2179-2195 Congress Street

Re: Supports for Precast Fascia Panels
Union Mutual Office Building (7372)

Re: Union Mutual Office Building

Re: Home Office Project
Code Review - 121

HSA	HUGH STUBBINS and ASSOCIATES			PROJECT NO. UNION MUTUAL HOME OFFICE PORTLAND ME	DWG. NO. SD-64
	DATE 4/22/70	SCALE	BY FS

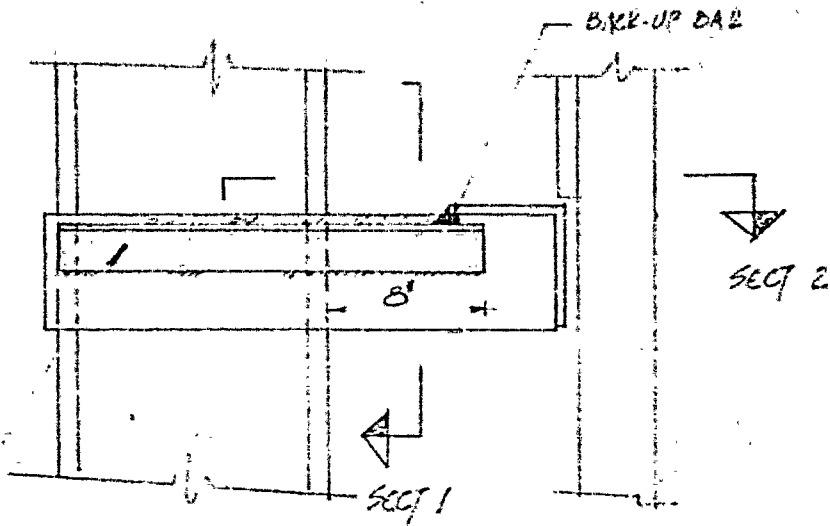
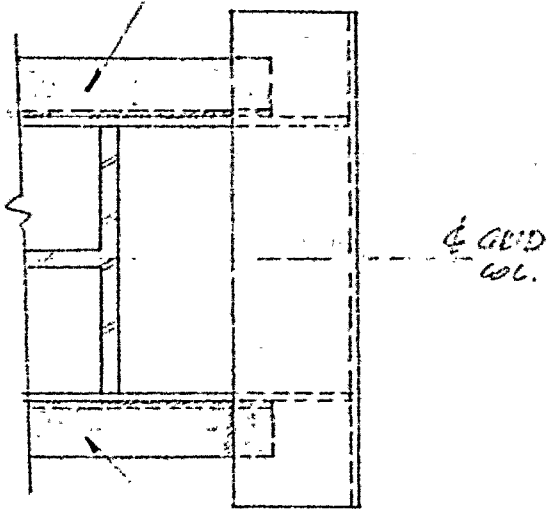
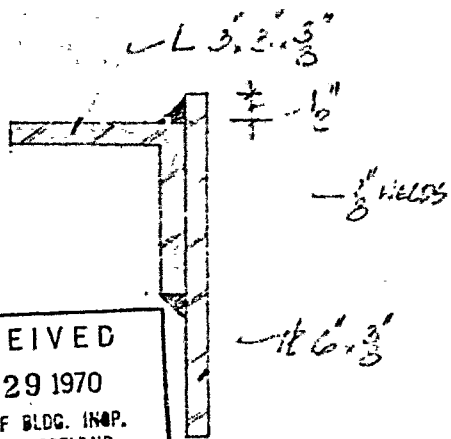
L TO REINFORCE BRACKET
TWO BEAMS FOR SUPPORT

ADDITIONAL
REINFORCEMENT FOR PRECAST
SUPPORT BRACKETS.

Subject *WALK*
CHECK PRECAST
SUPPORTS

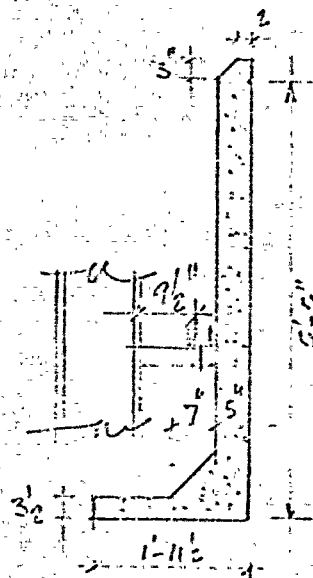
OVERSTRESSED BY *10%* STRESSFULLY SUFFICIENT

SINCE ONLY DL OF PANEL IS SUPPORTED. NO OTHER
LOAD WILL BE CARRIED.

We found that the support straps are about 10% over-stressed for the panel dimensions as outlined in shop drawings and in our sketch. This is structurally sufficient since only the deadload of the panel is supported and no additional over-stressing is anticipated. We advise, however, that care be used in placing the panels in order to avoid any possible overloading due to impact.

Subject VIBRO
CHECK RECAST
SILBOSS

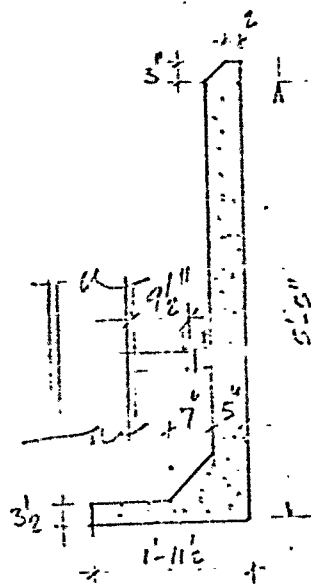
OVERSTRESSED BY 10% . STRUCTURALLY SUFFICIENT
SINCE ONLY DL OF PANEL IS SUPPORTED. NO OTHER
LOAD WILL BE CARRIED.

HSA	HUGH STUBBINS and ASSOCIATES		PROJECT NO.	DWG. NO.
	DATE 4/29/70	SCALE	BY FS	SD-64
			UNION MUTUAL HOME OFFICE PORTLAND, ME

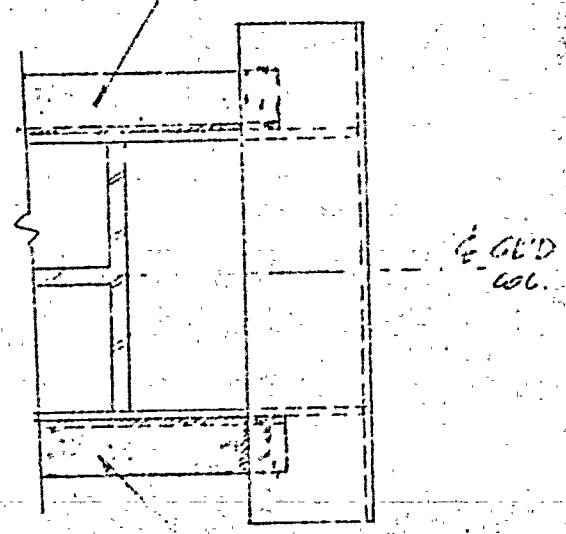
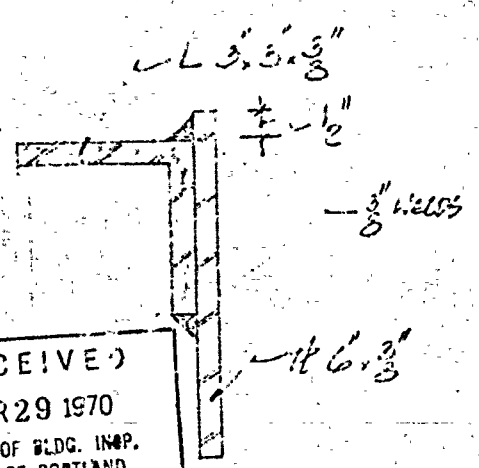
L TO REINFORCE BECKET
TWO REQUIRED PER SUPPORT

ADDITIONAL
REINFORCEMENT FOR PRECIP.
SUPPORT BECKET'S.
